XII. Summary of Comments and Responses
C. Comments and Responses
Transportation

**FIGURE J.1 (REVISED) SAN FRANCISCO CLEAN WATER PROGRAM
COMBINED SEWER SYSTEM CONCEPTUAL DIAGRAM**

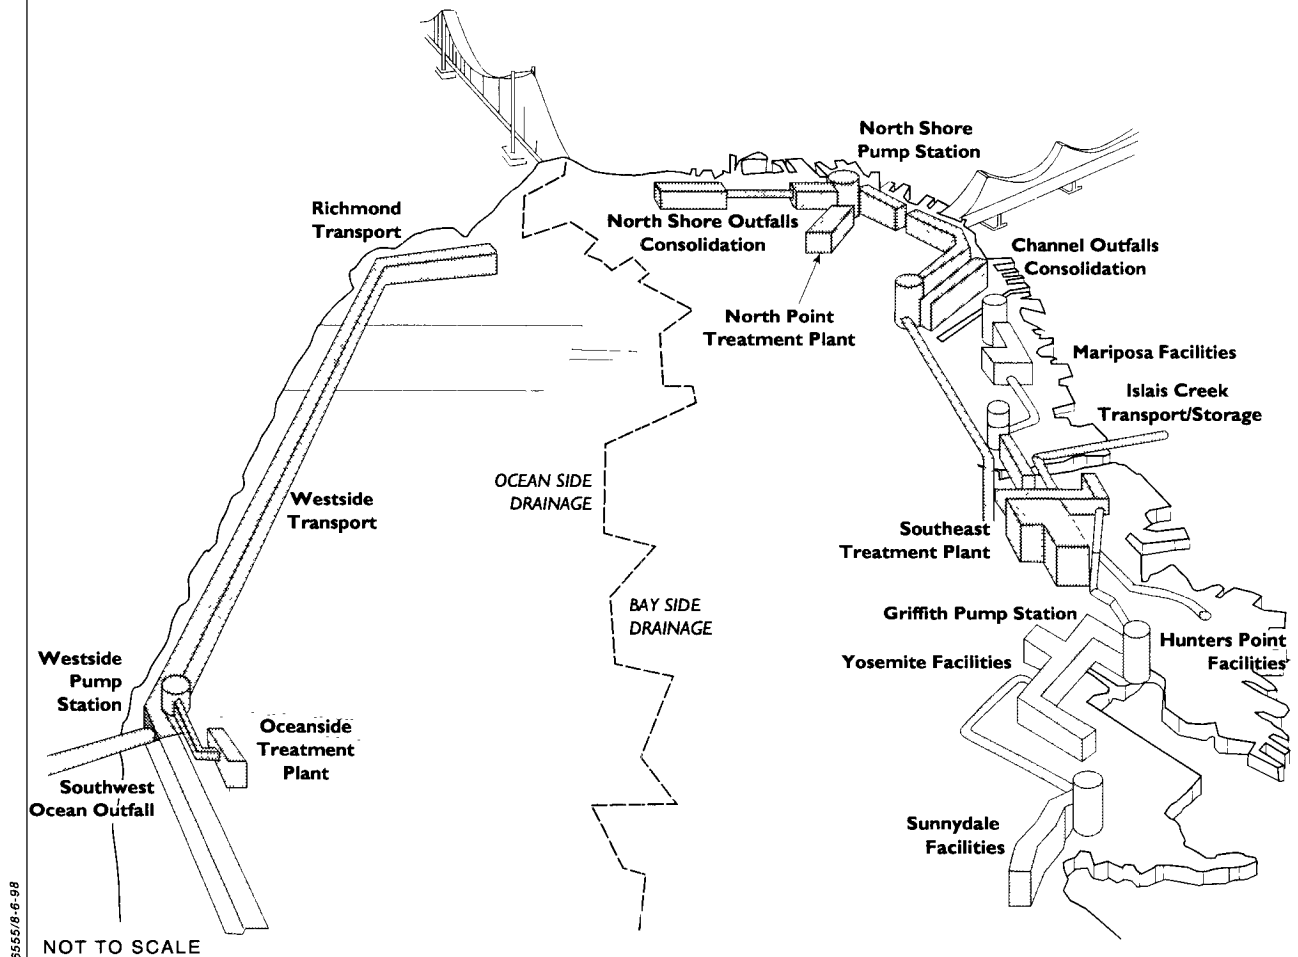
[T]here seems to be an oversight in Figure J.1, of Volume III. The map of San Francisco, which illustrates the Cities' waste treatment system shows a "Cross Town Tunnel (not yet scheduled for construction)." The Board of Supervisors has stated in a resolution last year that this is no longer a feasible solution to expanding the system and that the city will not be considering this option in the future. Therefore, it should be removed from the figure and any reference to it omitted. (*Michael J. Paquet, Environmental Committee Chair, Surfrider Foundation, San Francisco Chapter*)

And first I'd like to also state the oversight of the cross-town tunnel being in the report in Figure J-1, very back end of the third volume.

These comments recommend revising Figure J.1 on p. J.2 of Appendix J, Hydrology and Water Quality, to eliminate the reference to a cross-town tunnel. The *San Francisco Wastewater Master Plan* includes a cross-town tunnel to transport wastewater from the Bayside to the oceanside. In 1974, when the Wastewater Master Plan was adopted, wastewater discharge standards were changing rapidly, and the City believed future restrictions on wastewater discharges to the Bay could necessitate this major capital project. However, the Regional Water Quality Control Board never required the construction of the tunnel as a National Pollutant Discharge Elimination System (NPDES) permit requirement, and San Francisco now complies with its NPDES permit requirements. See also the responses regarding “Background Regarding the Existing Combined Sewer System” on pp. XII.232-XII.238 and “Wet-Weather NPDES Permit” on pp. XII.371-XII.376. The San Francisco Board of Supervisors has not adopted formal legislation to remove the cross-town tunnel from the Wastewater Master Plan, but the tunnel is no longer considered a foreseeable option for future wastewater management./27/ As discussed in the response regarding “New Water Quality Standards” on p. XII.371, future changes to discharge standards cannot be anticipated; however, if new standards are ever promulgated that substantially affect the City’s ability to discharge wastewater to the Bay, the City would likely study reasonable options and alternatives to achieve the new discharge requirements at that time. Because the cross-town tunnel is no longer reasonably foreseeable, Figure J.1 has been revised as shown on the next page to remove the reference to it.
